437 MESILLA S.E. (Emil Mann Lot 13+14 Blk 3)
STANDARD REQUIREMENTS FOR DRAINAGE PLANS

CITY OF ALBUQUERQUE DRAINAGE REPORT

CITY OF ALBUQUERQUE
~~February 24~~ 1965

Proposed 80 acre subdivision - S $\frac{1}{2}$ SE $\frac{1}{2}$ Sec. 10, Twp. 10 N.
Range 4 E. Relevant to Drainage Report for New Mexico
Savings and Loan Association.

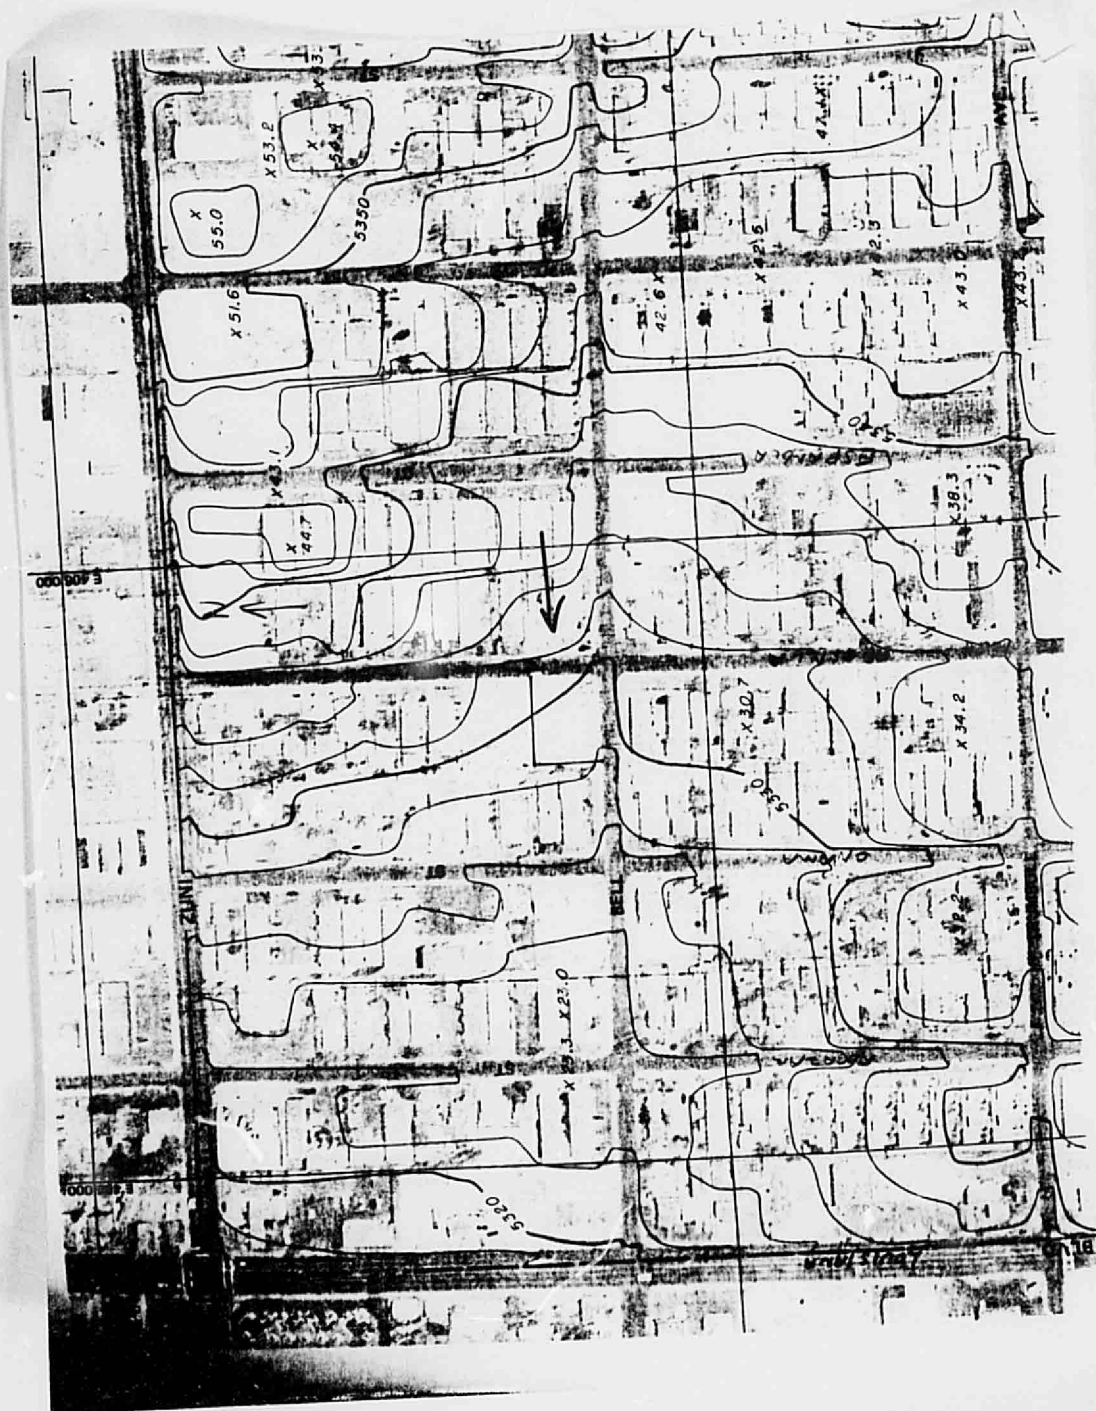
~~THE~~ ~~PROPOSED~~ 3' ELEV ABOVE TOP OF CURB
WILL HAVE TO BE ADDED TO. FLOODING POTENTIAL FROM
STREET IS VERY POSSIBLE.

NO Does development block drainage from adjacent property?
~~6" storm water pipe in the driveway~~

YES Is elevation of property line at least 0.3 ft. above top of curb?
~~THIS WILL HAVE TO BE A MUST, BECAUSE FLOODING FROM STREET IS VERY POSSIBLE.~~

NO Are ponds balanced with areas they drain (can area draining to each pond be easily identified and will actually water flow there)? The
plot plan must outline each drainage area. ~~SHOW THE AREA~~ **DRAWING**
